ATTACHMENT 3

PROPOSED TECHNICAL SPECIFICATION CHANGES

MILLSTONE 1, RELOAD 7

SEPTEMBER, 1980

Figure 3.11.1a - MAXIMUM AVERAGE PLANAR LINEAR HEAT GENERATION RATE (MAPLHGR) VERSUS PLANAR AVERAGE EXPOSURE. FUEL TYPE 8DB262.

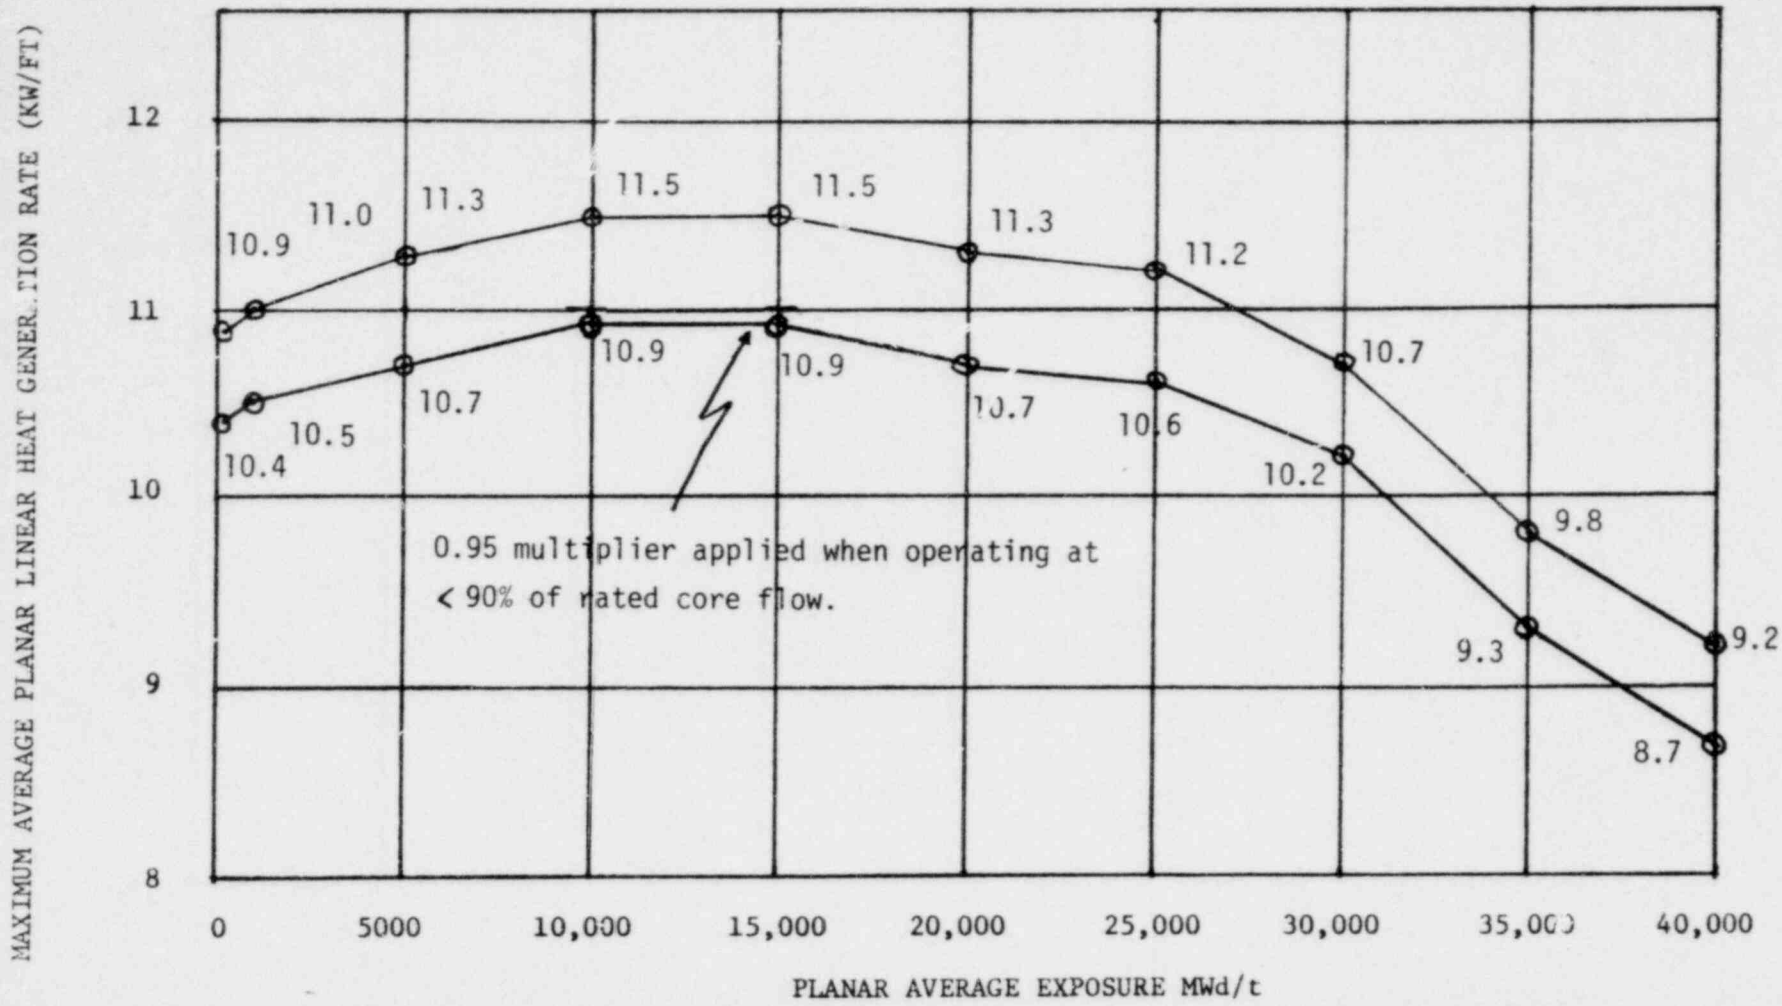
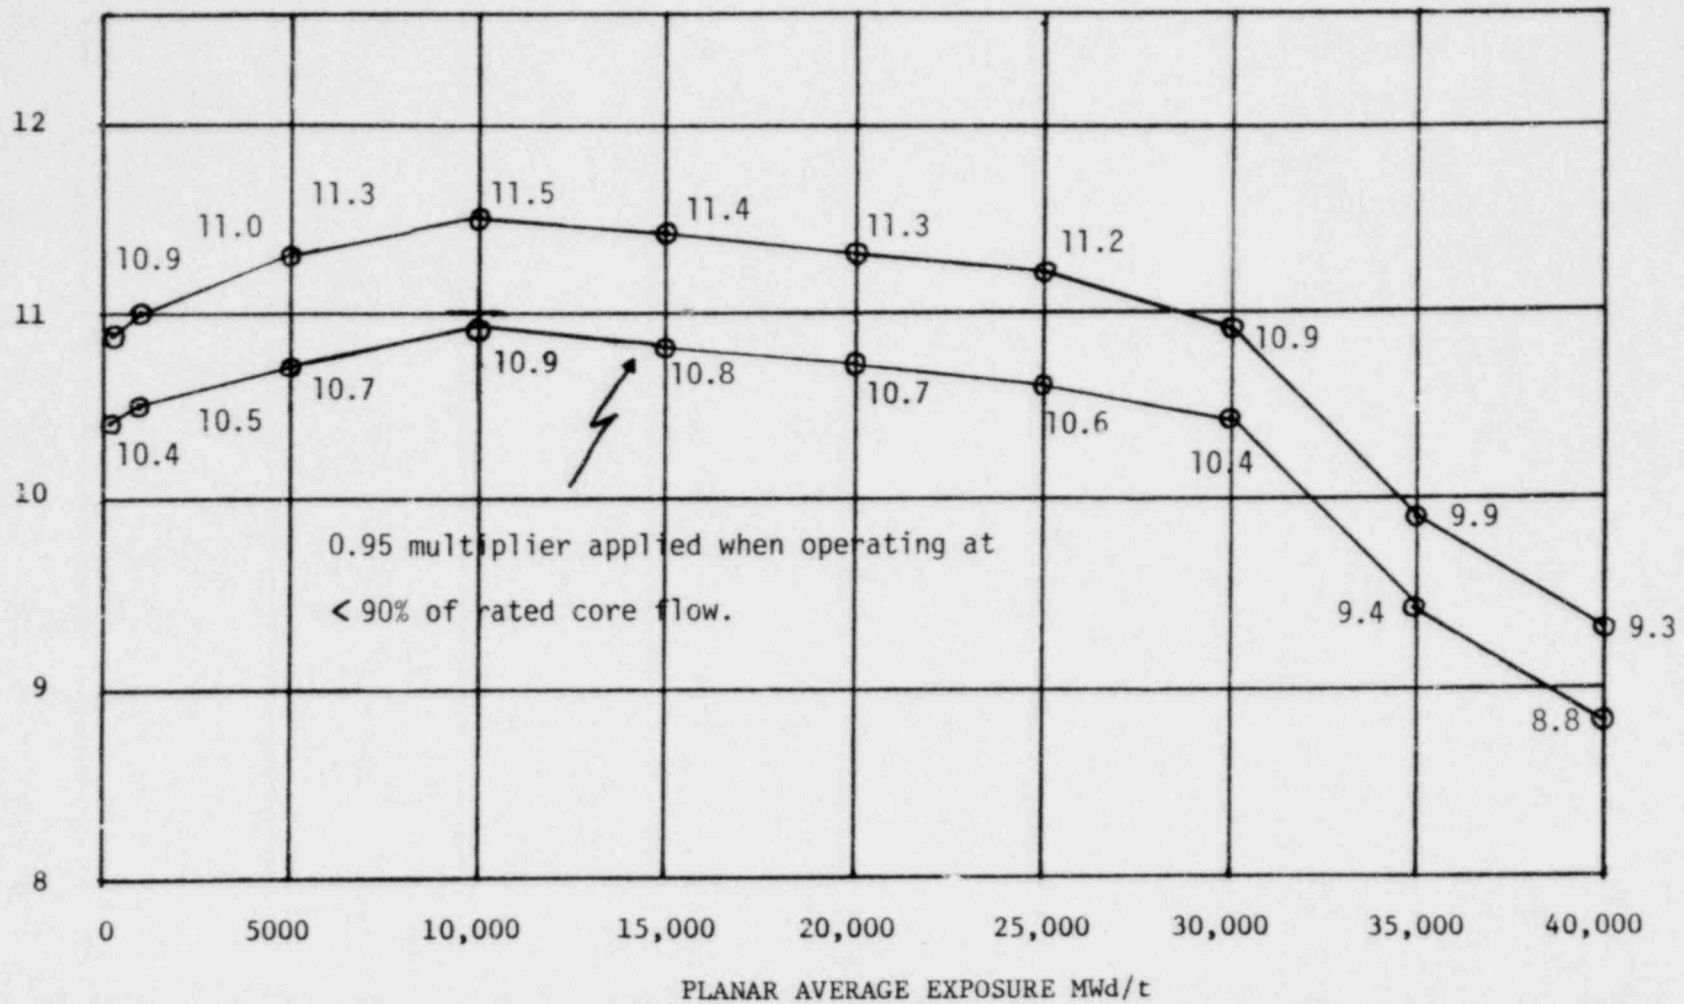
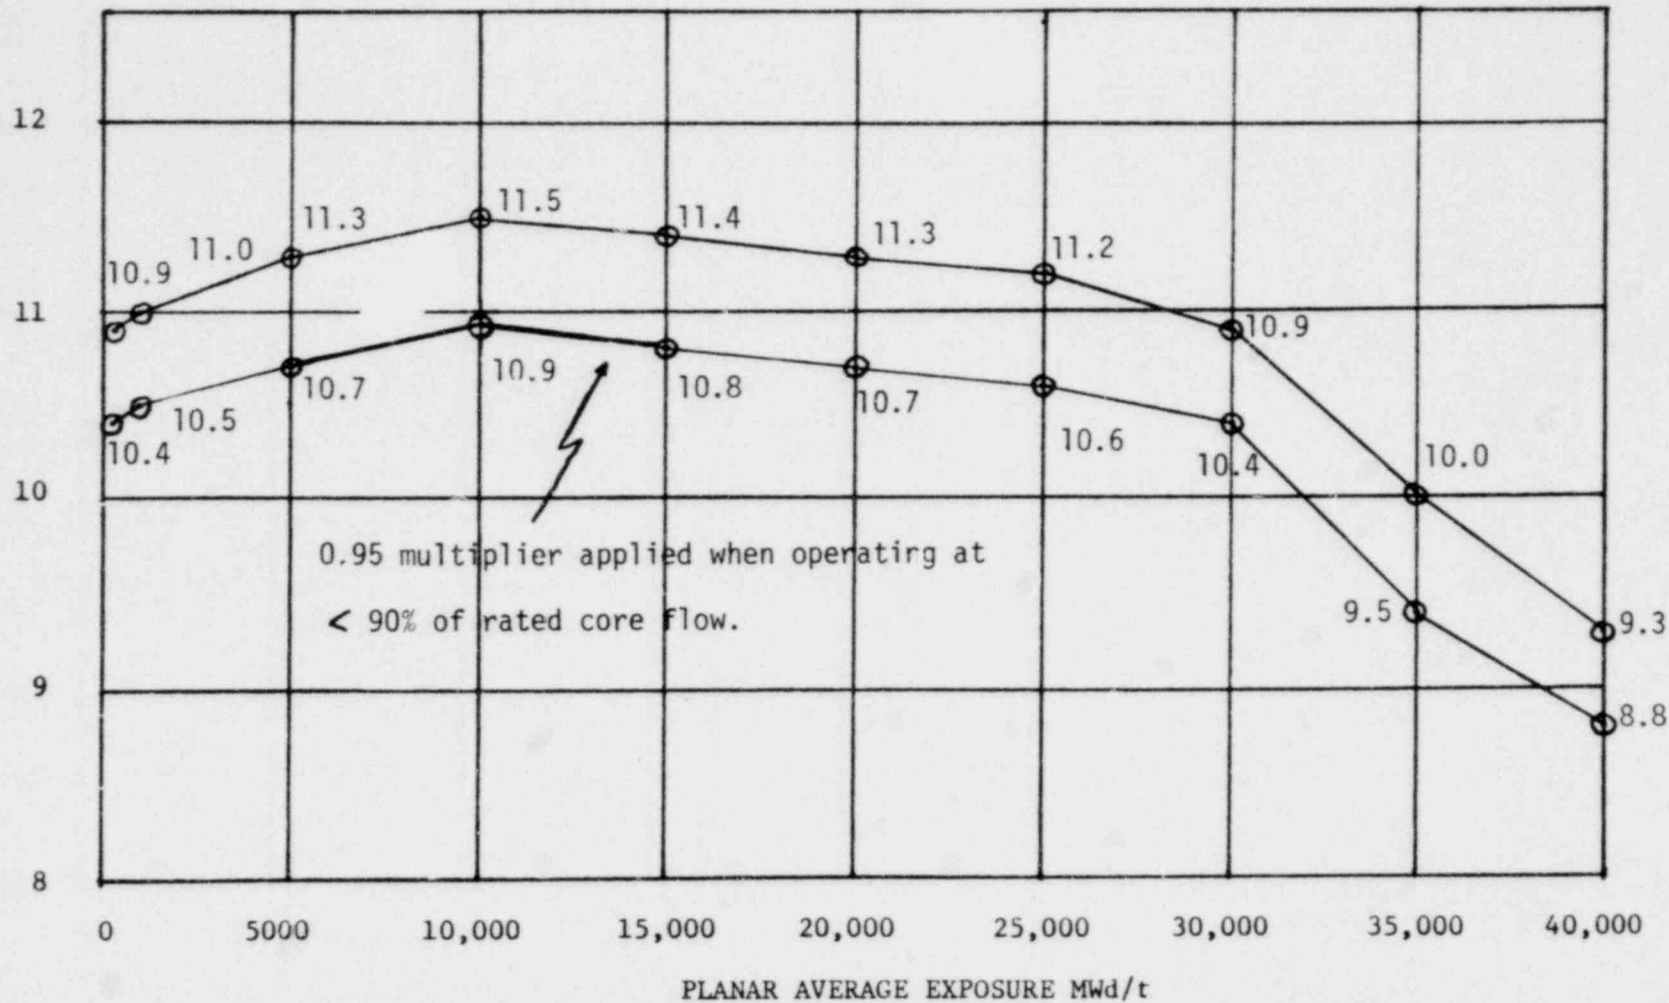
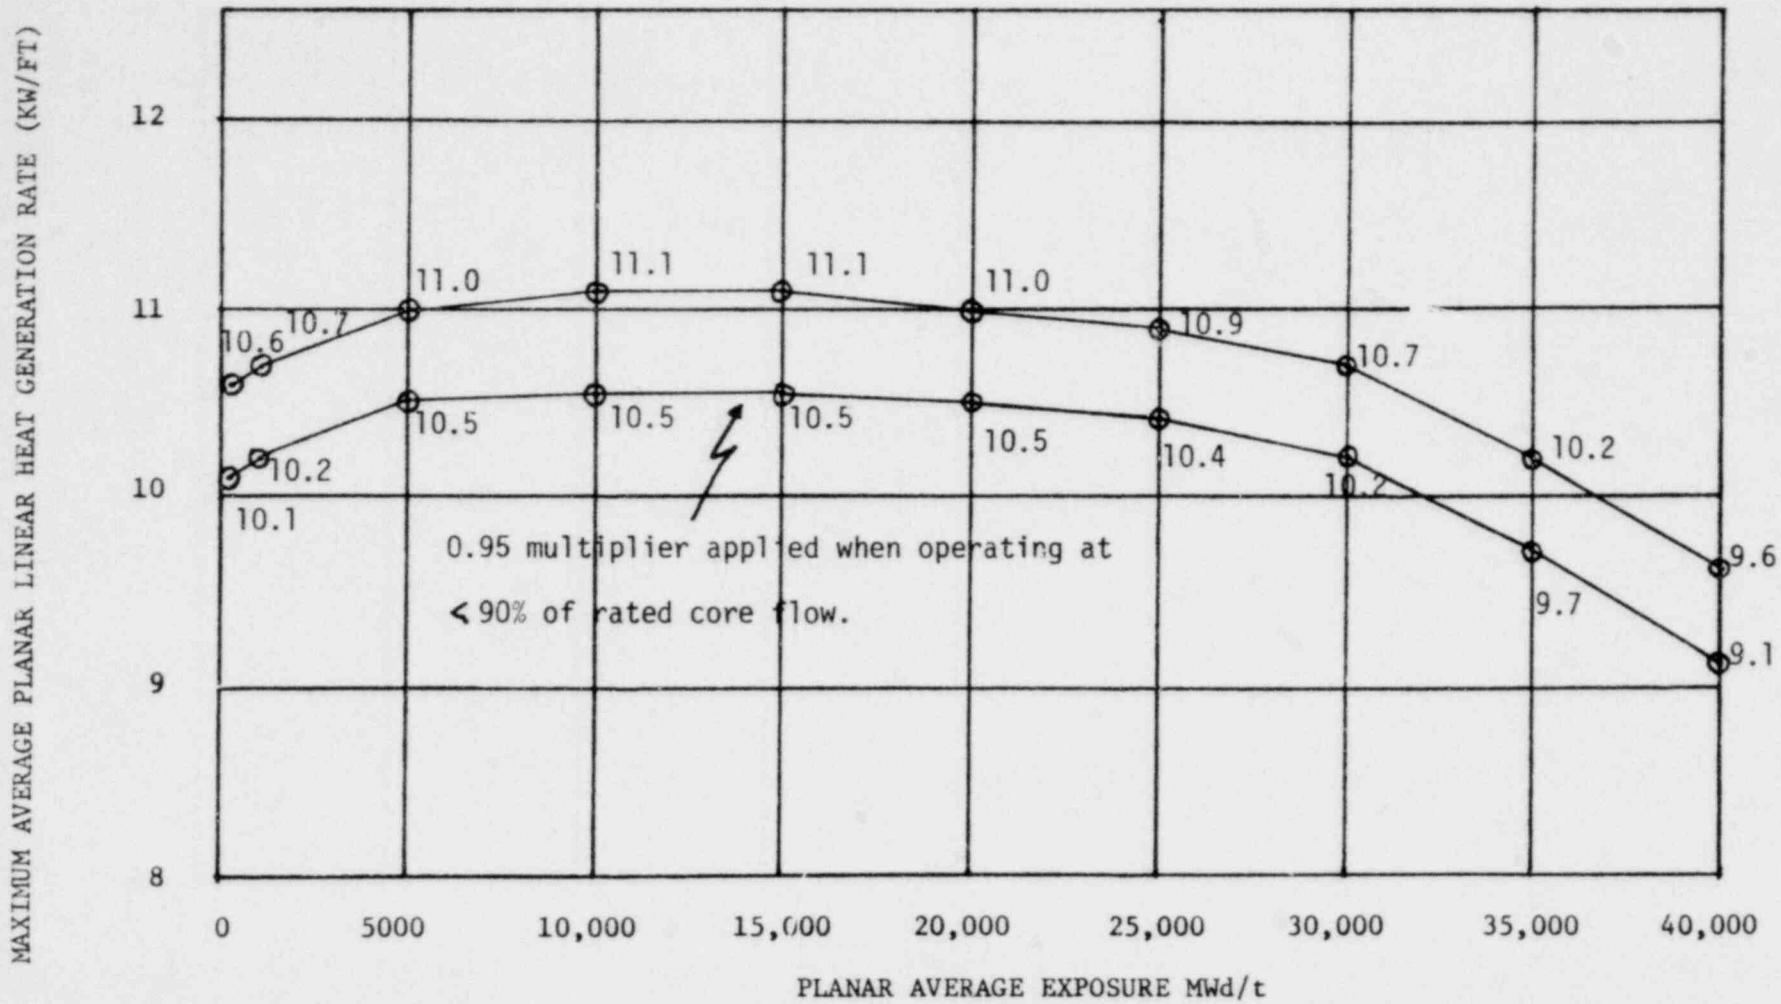
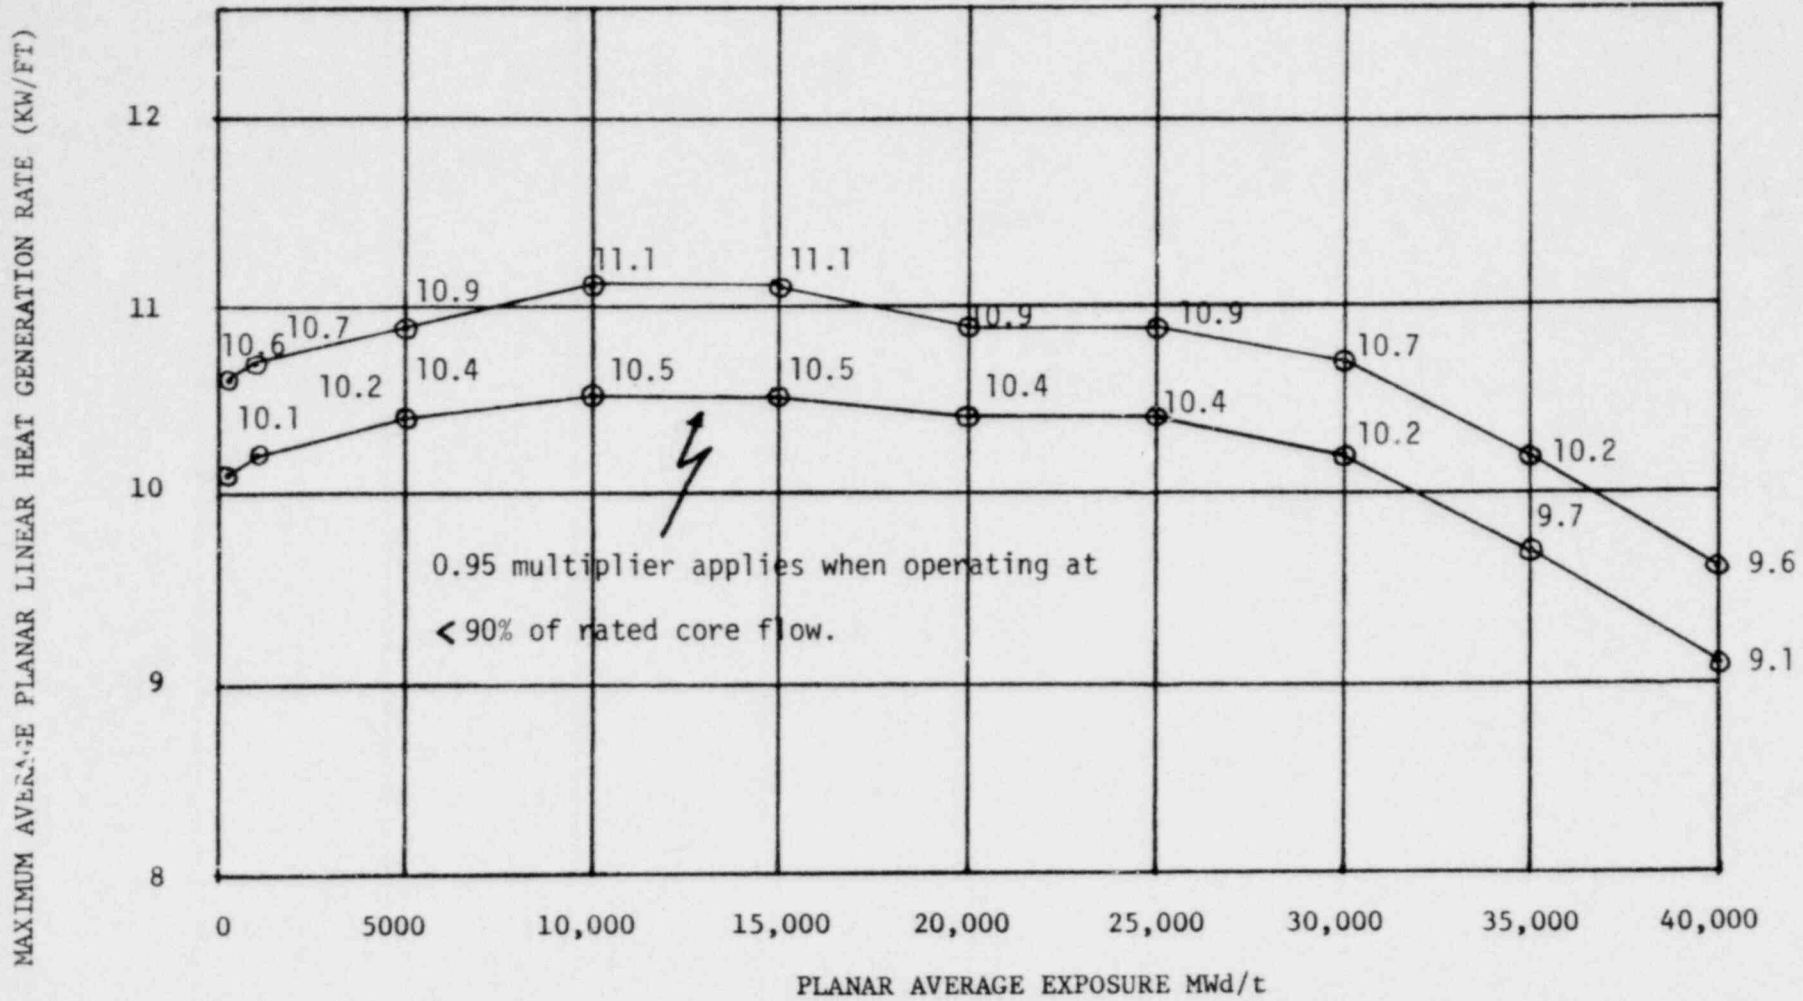
The Maximum Average Planar Linear Heat Generation Rate limits proposed herein, are based on accident analysis performed with the Cycle 8 core. The limits are supported by the enclosed topical report, NEDO-24085-1 (Attachment 2).

The existence of a gas turbine emergency power supply instead of a second diesel makes Millstone Unit No. 1 unique with regard to single-failure considerations in the LOCA analysis. Accordingly, the entire recirculation line break spectrum (both large and small breaks) has been analyzed in NEDO-24085-1, and reference to a lead plant is not necessary.

The small break analysis is consistent with the current Technical Specification bases contained in Amendment No. 67 to License No. DPR-21, transmitted by letter dated May 8, 1980, D. M. Crutchfield to W. G. Council. The addition of a fourth ADS valve to improve depressurization and reflooding capability is the only significant change.

1. During power operation, the APLHGR for each type of fuel as a function of average planar exposure shall not exceed the limiting value shown in Figure 3.11.1.
2. If at any time during operation it is determined by normal surveillance that the limiting value for APLHGR specified in Section 3.11.A.1 is being exceeded, action shall be initiated within 15 minutes to restore operation to within the prescribed limits. If the APLHGR is not returned to within the prescribed limits within two (2) hours, the reactor shall be brought to the Cold Shutdown condition within 36 hours. Surveillance and corresponding action shall continue until reactor operation is within the prescribed limits.
